Reviewers' Comments:

This paper reports the performance improvement of silicon single photon avalanche detector (SPAD); here the highlight is to employ a surface nano-texturing in order to utilize light trapping and reduce surface reflection. By doing so, they could get similar timing jitter but much enhanced photon detection efficiency (PDE).

Figure C-1 Dark current measurements for light trapping (nano-structured surface) and control SPADs.

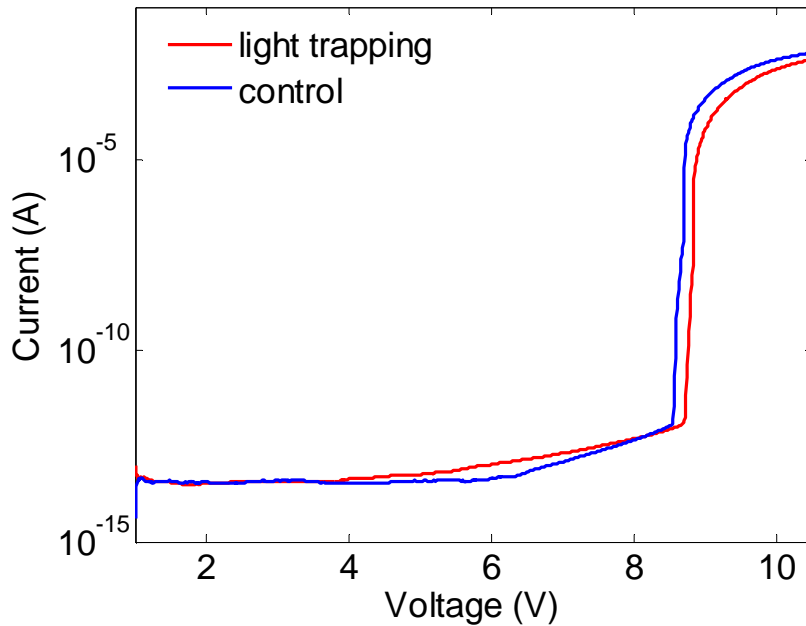
1) In practical viewpoints, nanostructuring of the surface might degrade the device performance, dark current in particular.

We would like to thank the reviewer to think our work "of high interest in scientific community". We follow the reviewer's suggestion to implement measurements of dark current and dark count rate (DCR) of the nano-texturing SPAD. By comparison, SPAD dark currents remain almost the same after nano-texturing. SPAD DCRs are, however 2-3 times higher after nano-texturing yet remain within the same order of magnitude. Detailed measurement results are shown below.

In Fig C-1, IV measurements show that dark currents for 20 μm diameter SPADs are about the same in the low-reverse-bias regime, for both the nano-texturing and control (without nano-texturing) SPAD. Under higher voltages, the nano-textured SPAD does induce a very small increase in dark current and a small increase in breakdown voltage. The slight shift is observed in SPADs fabricated on both Si substrates and SOI substrates.

Figure C-2 Dark count rate comparison of thicker junction SPADs with and without nanostructured surface.

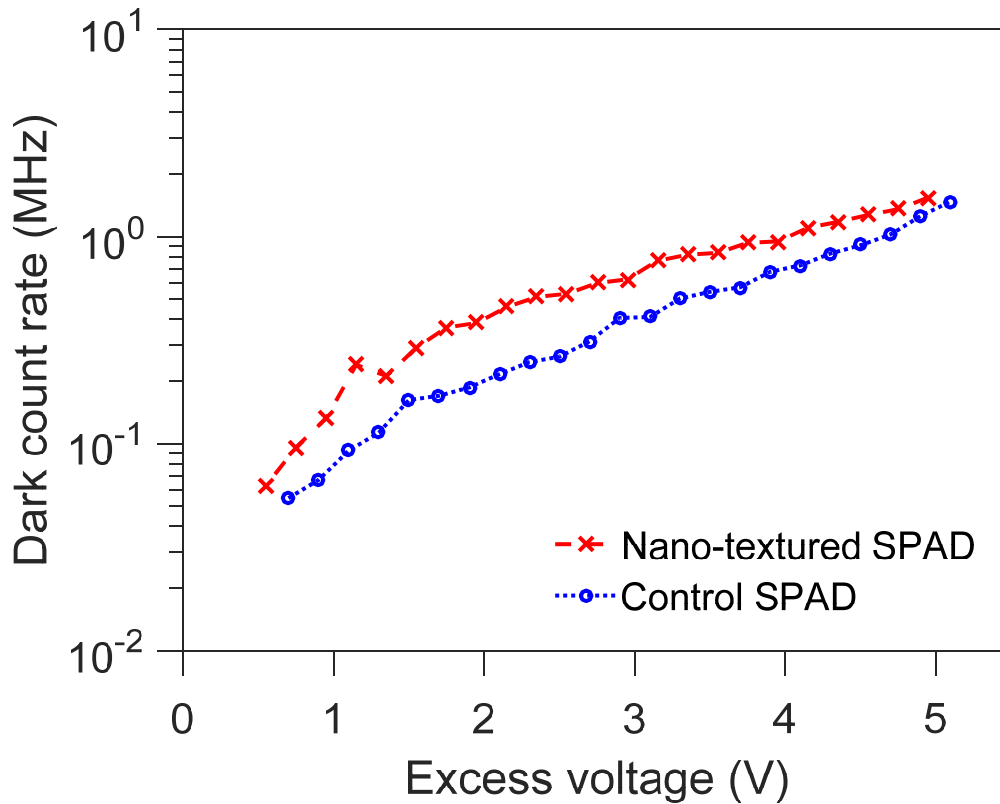
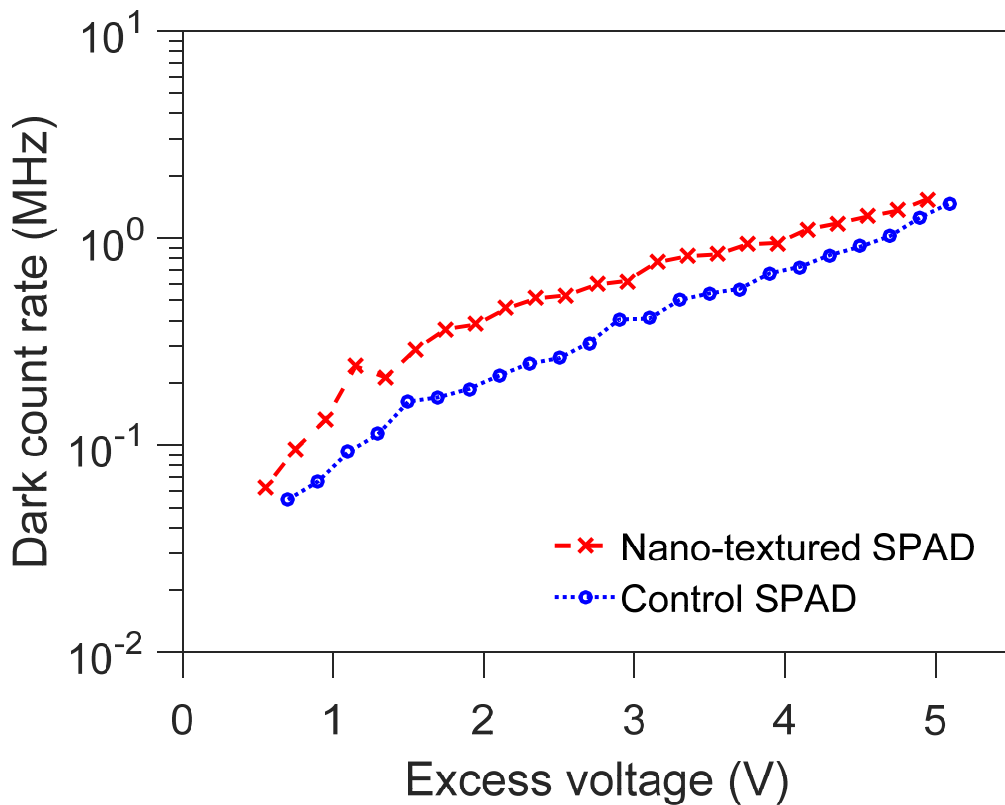
- The DCR is so high that it may mask any subtle difference between the light trapping SPAD and the control one, thus not proving that the nano-structured pattern is not affecting DCR.

We appreciate the reviewer for this valuable comment. We agree that the high DCR may influence the difference between the nano-texturing and control SPAD. Therefore, we re-fabricate a batch with nanostructures on a Si substrate and deliberately increase the epitaxy thickness. In this way, DCR is reduced to 10 kHz – 1 MHz. Although strong light trapping is missing in these newly fabricated thicker-junction samples, we believe that they provide a reasonable measure of the influence of the nanostructures. In Fig. C-2 below, nano-textured SPADs have about 2-3 times more DCR than control SPADs. The results show that, nanostructures degrade SPAD DCR but remain within the same order of magnitude, at least on a 100 kHz scale. To further prevent degradation, we expect that an atomic layer deposition (ALD) of Al_2O_3 thin film will help. ALD of Al_2O_3 is a relatively easy and low cost approach to reduce surface recombination of nano-textured surface. This has been demonstrated in Ref [1] with black silicon solar cells, whose efficiency has dramatically increased with help of Al_2O_3 ALD.

Fig. C-2 is also added to the revised manuscript as Fig. 6. And the manuscript is revised as:

Figure C-3 Photon distribution at a wavelength of 905 nm after being diffracted by 850 nm period nanostructures. Black arrows represent the first three orders of diffraction based on 1D grating theory.

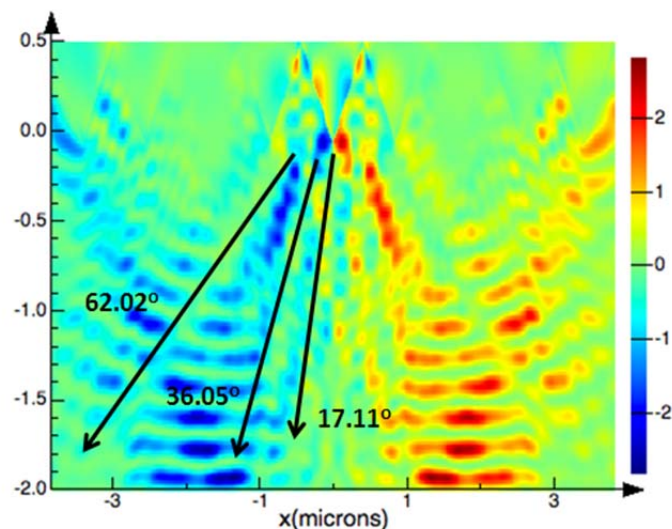
In addition the waveguiding effect of texturing would be detrimental effect in the crosstalk between neighbouring pixels

in imaging array for example. Though the authors suggest deep trench isolation with metal sandwiched by dielectrics,

We thank the referee for this valuable comment. We agree that metal sandwiched by dielectrics will complicate the process. At the same time, dielectric DTI has been used in CMOS image sensor prototypes recently ([2], [3]). This paves way to dielectric-metal-dielectric sandwiched DTI structure, a techniques that is slightly complicated but feasible.

In Fig C-3, 3D simulations reveal that the diffraction of photons roughly follows the grating theory. The critical angle for total internal reflection between Si and SiO₂ is 66.2°, which suggests that by simply using oxide DTI the majority of photons will be reflected back instead of penetrating to the adjacent pixels. This means that the crosstalk will be limited, even with a dielectric-filled DTI. A dielectric-metal-dielectric sandwich DTI will thus further help reduce optical crosstalk.

Figure C-4 Thermal oxide serves as a “weak” guard ring. **(a)** Electric field distribution when biased at -10 V. The simulated SPAD has a PIN junction as designed and goes through a thermal oxidation step.

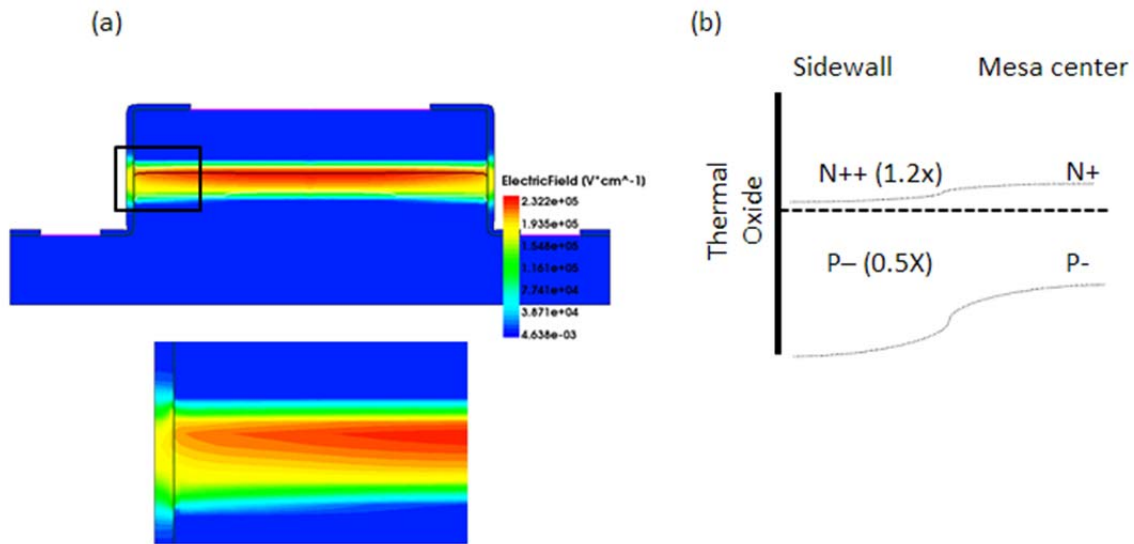
- The authors fabricated a mesa-type device, with 100 nm oxide layer on the walls: I think that this passivation layer does not provide any "guard ring" effect. Could you better explain the guard ring mentioned on page 3, line 58-59?

During the thermal oxidation process, dopant diffusion and segregation at the oxide interface leads to an accumulation of phosphorus and depletion of boron at the sidewall [4], which results in reduced electric field at the sidewall junction. This leads to a guard ring effect, which is rather weak compared to standard techniques, so SPAD DCR remains high. Fig C-4 shows the device simulation result of electric field distribution within the depletion region at a reverse bias of 10 V and an explanation of the weak guard ring effect.

Line 69: "Thermal oxidation of 100nm thickness on the sidewall and top serves as a passivation layer and a weak guard ring (due to dopant segregation at the oxide interface)."

Figure C-5 Simulated epitaxial doping profile before and after thermal oxidation

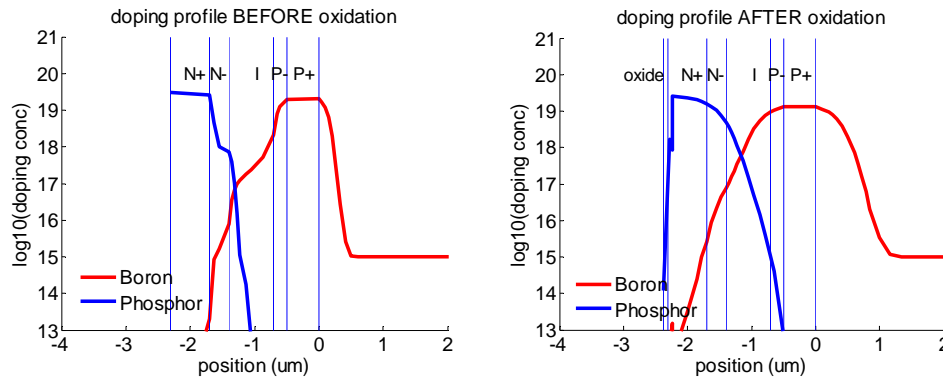
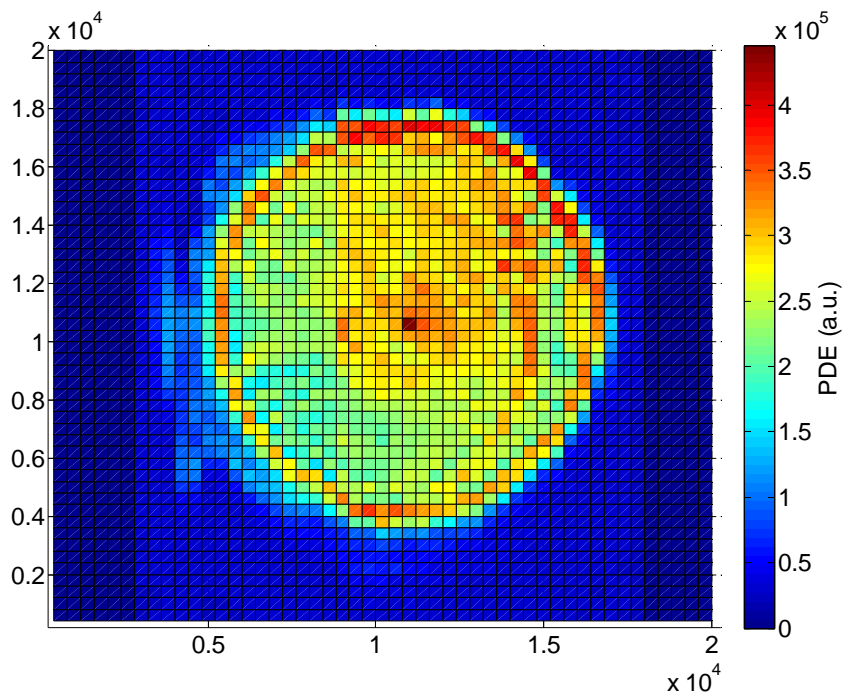
- Page 4: The breakdown voltage is very low, showing that the electric field in the depleted region is quite high, thus leading to tunneling effects. It is even lower than the one simulated by the authors during the design: is this due to edge effects? Did the authors acquire a measurement of the electroluminescence emitted by the detector in Geiger-mode for checking if breakdown probability is uniform all over the active area or is higher on the edge?

We thank the reviewer for this comment. The low breakdown voltage is due to two reasons: dopant diffusion during thermal oxidation and edge effects.

The first issue, dopant diffusion, comes from the thermal oxidation process at 1000 °C. Fig C-5 plots the dopant distribution before and after the oxidation process. After the thermal oxidation, there is a higher doping in intrinsic region. So the depletion width decreases, which reduces the SPAD breakdown voltage.

For the second issue, we measured PDEs with a focused light spot and scanned across a light trapping SPAD. Results in Fig C-6 prove the existence of edge effects. PDE on the edge is $\sim 20\%$ higher than that in the center, which implies more avalanche events occur in regions close to SPAD edge.

Figure C-7 Three possible scenarios when gate voltage is ON and an oscilloscope monitors only a portion of the gate time. (a) No avalanches or avalanches happen after the monitoring window. (b) Avalanches happen during the monitoring window. (c) Avalanches happen before the monitoring window.

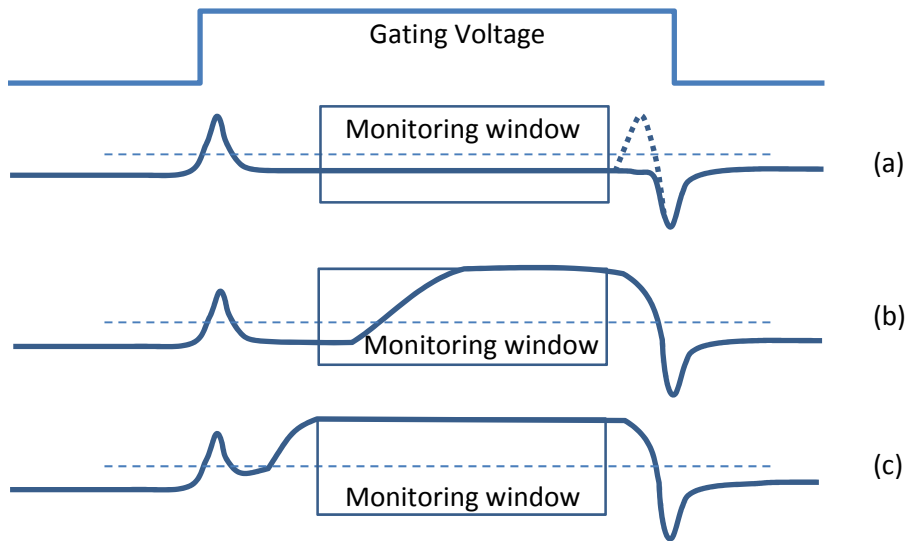
- On page 6 and Fig. 4: the authors mention that the decrease of PDE at high excess bias voltages is due to higher DCR and leakage currents. I agree that this can be the case for the acquired raw

data, with maybe an additional contribution from the afterpulsing effect, but it has to be properly considered and corrections have to be applied. The authors should better explain how these measurements were acquired and processed.

We highly appreciate the reviewer's comment. After careful debugging, we have to admit that the decrease of PDE at very high excess voltage is mainly due to our characterization negligence. After correction, the observed PDE reaches saturation when increasing excess voltages. The results have been updated in Fig 5 in the revised manuscript. As shown in the Appendix I, we also conduct simulations and experiments to confirm that the high DCR or multiple photons per pulse will not affect PDE results using our method.

Below we would like to explain how we obtained the incorrect result. In characterization, we use a gated quenching configuration with 10 ns gate width at 1 kHz repetition rate. A digital storage oscilloscope is used to capture SPAD responses in a 6.4 ns monitoring window out of the 10 ns gate width. Then, a data processing program is used to digitally discriminate whether an avalanche occurs in the captured response, by cross-threshold method. There are three possible scenarios to be captured by the oscilloscope, as shown in Fig C-7. These are (a) no avalanches within the monitoring window or the avalanches occur after the monitoring window; (b) an avalanche occurs right in the monitoring window; (c) an avalanche occurs before the monitoring window. In our previous program, scenario (c) was not discriminated from scenario (a), and they were both treated as "no trigger" in this detection period. As a result the measured PDE decreases when scenario (c) increased dramatically at very high excess voltages.

Afterpulsing should not be a concern since we use a gated quenching configuration. With repetition rate of 1 kHz, afterpulsing is measured to be minimal after 1 ms dead time.

Figure C-8 Pile-up effects in jitter distribution measurements and their corrections. **(a)** Raw data of measured jitter distributions of a light-trapping SPAD, affected by pile-up effect. **(b)** Jitter distributions after applying pile-up correction to the raw data in (a).

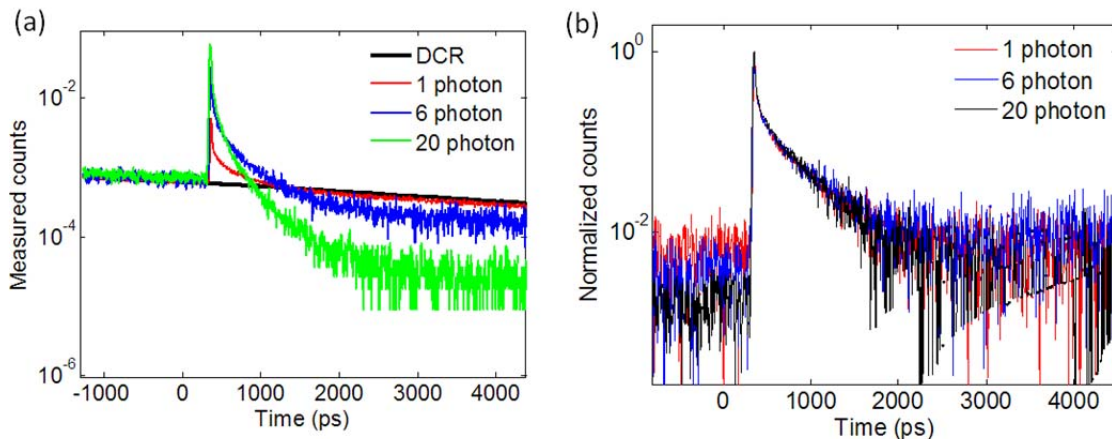
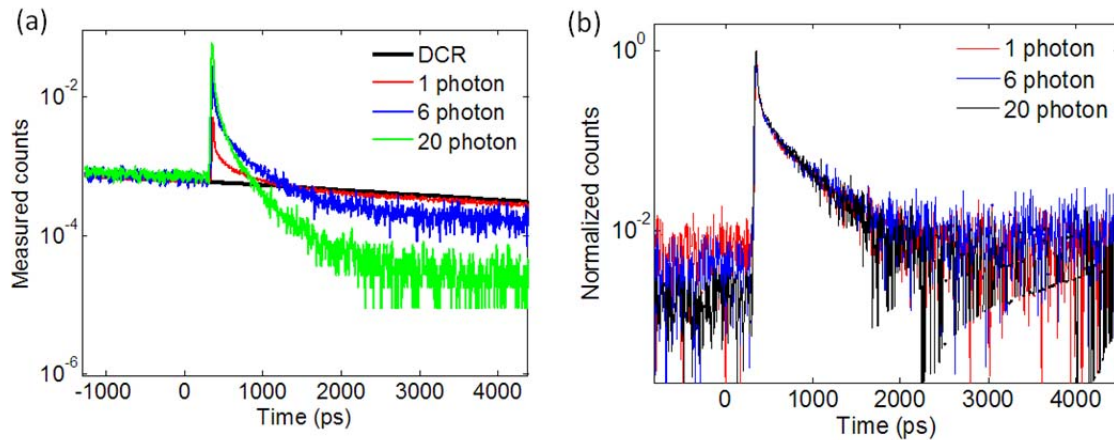
Figure 4 appears to show single-photon detection efficiency. These results have some potential from the point of view of improvement between devices, but I am very concerned that an SPDE of up to 25% is observed when a pulse containing 6.5 photons per pulse is incident. This surely will lead to highly distorted results as time-correlated single photon counting must operate only in the regime of low probability of detection, typically below 5% probability of a detection event when compared to the incident pulse rate. Otherwise, this will lead to highly unreliable SPDE and jitter results. (See “Pile-Up Effect” in W. Becker “Advanced Time-Correlated Single Photon Counting Techniques” Springer 2005). Essentially, the SPDE is the probability of a single-photon being measured, it is not the probability of a detection event if multiple photons are incident – that probability will always be higher than the SPDE. Generally, such an SPDE measurement will be valid if the probability of detection is very low, so a combination of high detection efficiency and

For jitter measurement, we also appreciate that you brought up the idea of pile-up effect, because our original measured jitter distribution did suffer from that and without any correction. To get correct results, we adopt the pile-up correction program as detailed in Appendix II, switch the laser wavelength to 940 nm and redo the measurements at 1 photon per pulse. At 940 nm wavelength, PDEs for both SPADs are lower (measured to be 15% for light-trapping SPADs and 5.5% for control SPADs). To demonstrate that pile-up correction method works, average 1, 6 and 20 photons per pulse were used to test the same light trapping SPAD. Fig C-8(a) (copied

below) shows the original measurement results, where pile-up effects are seen clearly, especially in the high photon flux scenarios. Then, by using a simple pile-up correction algorithm [11], the original jitter distribution is successfully restored, as shown in Fig C-8(b). The jitter distributions under 1, 6 and 20 photons per pulse overlap with each other quite well, which confirms that the pile-up correction works well under high photon flux. A FWHM of 25 ps, FWTM of 265 ps, and tail of 1380 ps can be read from the corrected jitter distributions. We have updated jitter distribution in Fig. 5(d) in the revised manuscript, to the pile-up corrected ones measured at 1 photon per pulse and at 940 nm wavelength.

Figure C-9 Reflection measurement of 850 nm period inverse pyramid nano-structures on Si substrate at different injection angles.

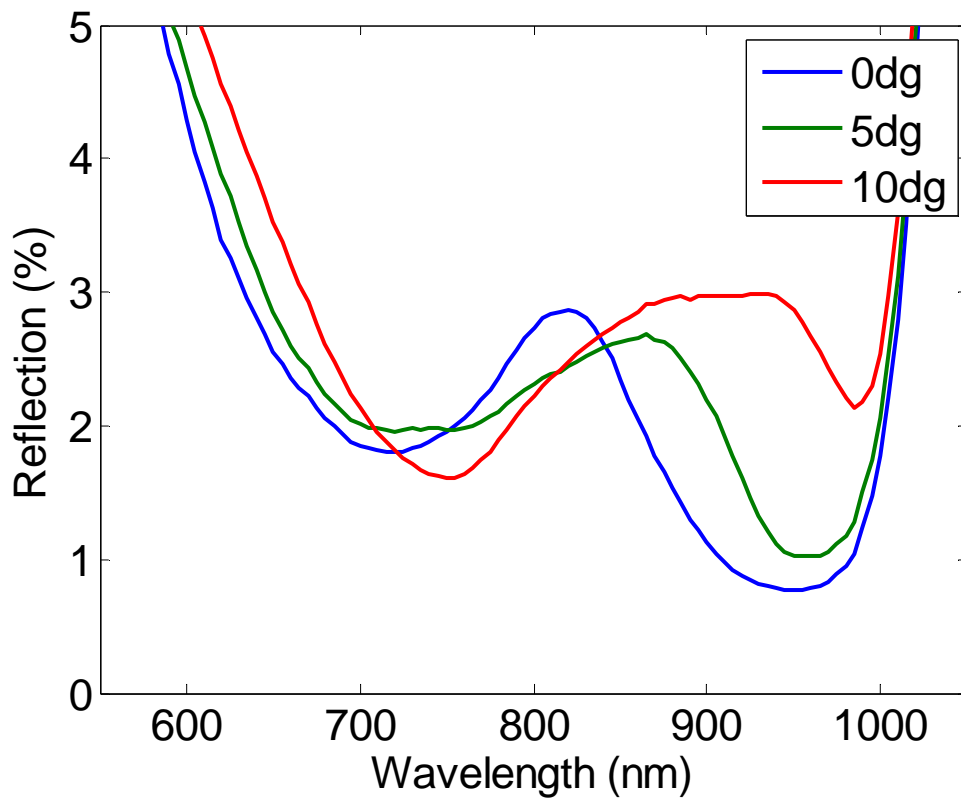
- Supplementary information, page 2, Fig. S2 a: reflection measurements were acquired from a sample with a 700 nm period of the nano-structured pattern, while all the other measurements were from a sample with 850 nm period. Why did you change the pattern period? Do you have these measurements from the sample with 850 nm period?

Thanks for your comments. Samples with an 850 nm period are characterized in the manuscript and their reflections are shown below in Fig C-9. It demonstrates good anti-reflection, which limits reflection to below 5% in the near infrared regime. In addition, the result also shows a clear shift of resonance. However, at larger injection angles, the resonance wavelength is approaching the responsivity limit of Si photodiodes that we use. Therefore in the supplementary files, we used reflection results from the sample with 700 nm period nano-structures, which shows a clearer shift of resonance.

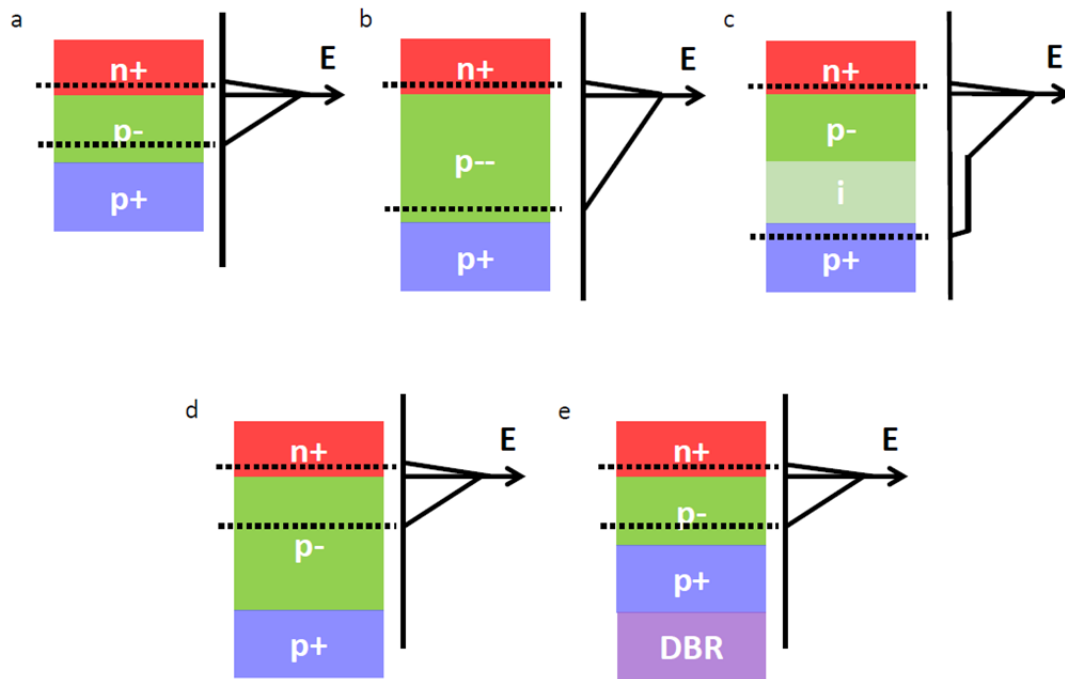
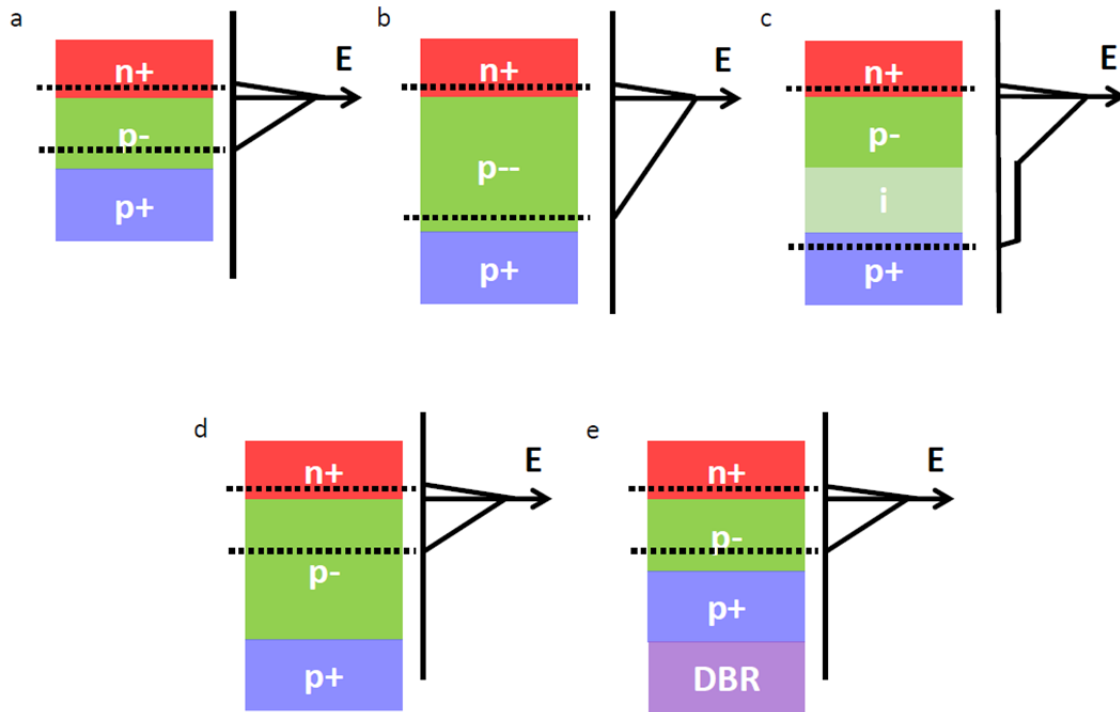
- Page 2, line 33: at least one reference is needed here for supporting the cited numbers.
- Page 2, line 35-36: the authors should better describe the three ways for collecting photons by properly referring to the differences among the three regions (e.g. in terms of electric field).

We have included a new figure in the manuscript to better describe how to collect photons in different regions. The figure is copied here as Fig C-10.

We appreciate the reviewer for pointing out this issue, because we confused “depletion region” with “avalanche region” in the original manuscript. Within the depletion region, only electric fields larger than 3×10^5 V/cm will induce avalanches and multiplications. While it only requires $\sim 1 \times 10^5$ V/cm electric fields to get electrons in Si to reach saturation velocity. The difference is presented in Fig. C-10 (b) and (c).
